R. E. GINNA NUCLEAR POWER PLANT

AMENDMENT TO FACILITY OPERATING LICENSE

Amendment No. 15
License No. DPR-18

SAFETY EVALUATION BY THE OFFICE OF NUCLEAR REACTOR REGULATION
RELATED TO AMENDMENT NO. 15 TO FACILITY OPERATING LICENSE NO. DPR-18
ROCHESTER GAS AND ELECTRIC CORPORATION
R. E. GINNA NUCLEAR POWER PLANT
DOCKET NO. 50-244

Figure 3.1-1 Reactor Coolant System Heatup Limitations Applicable for 21.0 Effective Full Power Years. T_{ERROR} = 10°F, P_{ERROR} = 60 PSI

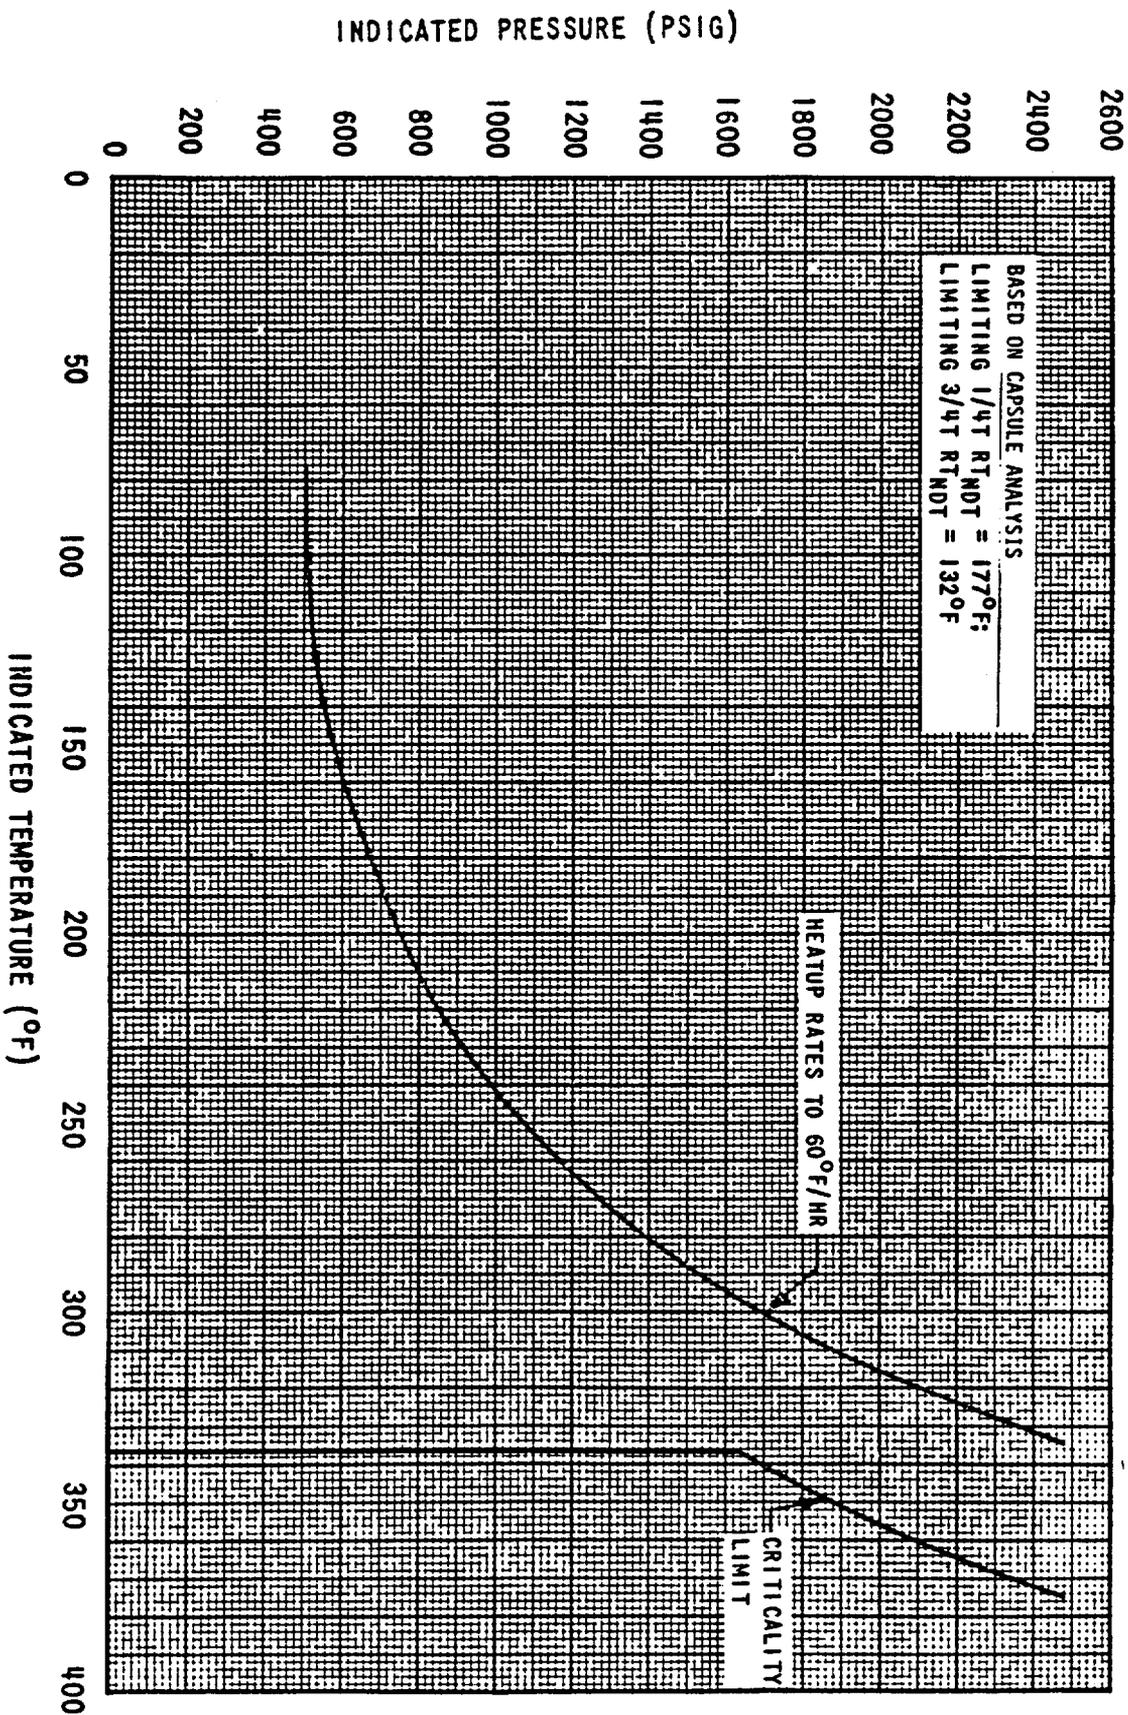
3.1.2.1 The reactor coolant temperature and pressure and system heatup and cooldown rates (with the exception of the pressurizer) shall be limited in accordance with Figures 3.1-1 and 3.1-2 for the first 21.0 effective full power years.

a. Allowable combinations of pressure and temperature for specific temperature change rates are below and to the right of the limit lines shown. The heatup and cooldown rates shall not exceed 60°F/hr and 100°F/hr, respectively. Limit lines for cooldown rates between those presented may be obtained by interpolation.

b. Figures 3.1-1 and 3.1-2 define limits to assure prevention of non-ductile failure only. The limit lines shown in Figures 3.1-1 and 3.1-2 shall be recalculated periodically using methods discussed in the Basis Section.

The pressure-temperature limits have been evaluated using the method documented in Standard Review Plan 5.3.2. The ΔRT_{NDT} for the SA-847 weld metals was estimated using the Guthrie mean formula and the chemical composition for welds fabricated from heat 61782 weld wire, which is reported in B&W Report BAW 1511P. The results of our review indicates that the proposed pressure-temperature limits are acceptable until the intermediate to lower shell weld accumulates a neutron fluence of $1.5 \times 10^{19} \text{ n/cm}^2$ ($E > 1\text{MEV}$). Based on our evaluation of the licensee's data in his August 19, 1985 supplemental submittal we conclude that the critical weld will not accumulate a fluence of $1.5 \times 10^{19} \text{ n/cm}^2$ for 21 EFPY; therefore, the proposed heatup and cooldown rate curves are acceptable.

Figure 3.1-2 Reactor Coolant System Cooldown Limitations Applicable for 21.0 Effective Full Power Years. $T_{\text{ERROR}} = 10^{\circ}\text{F}$, $P_{\text{ERROR}} = 60 \text{ PSI}$

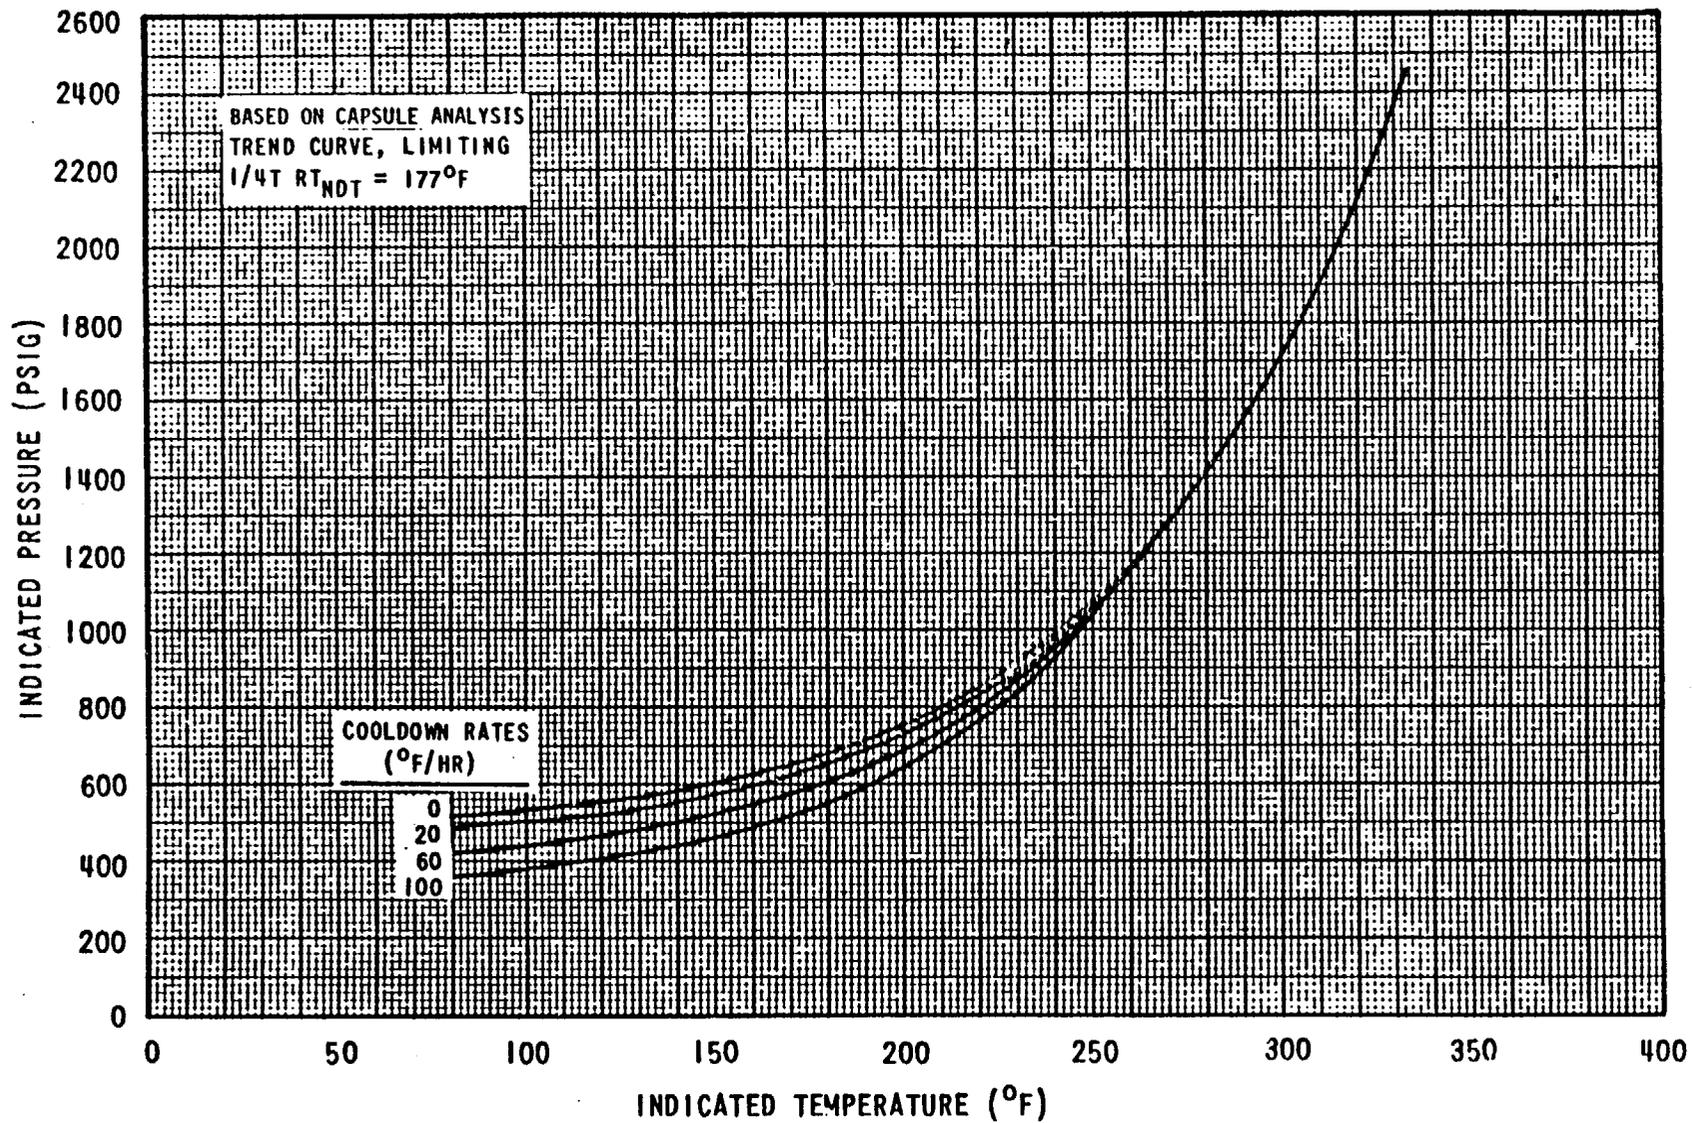
Because operation control is on coolant temperature and cooldown rate may vary during the cooldown transient, the limit curves shown in Figure 3.1-2 represent a composite curve consisting of the more conservative values calculated for steady state and the specific cooling rate shown.
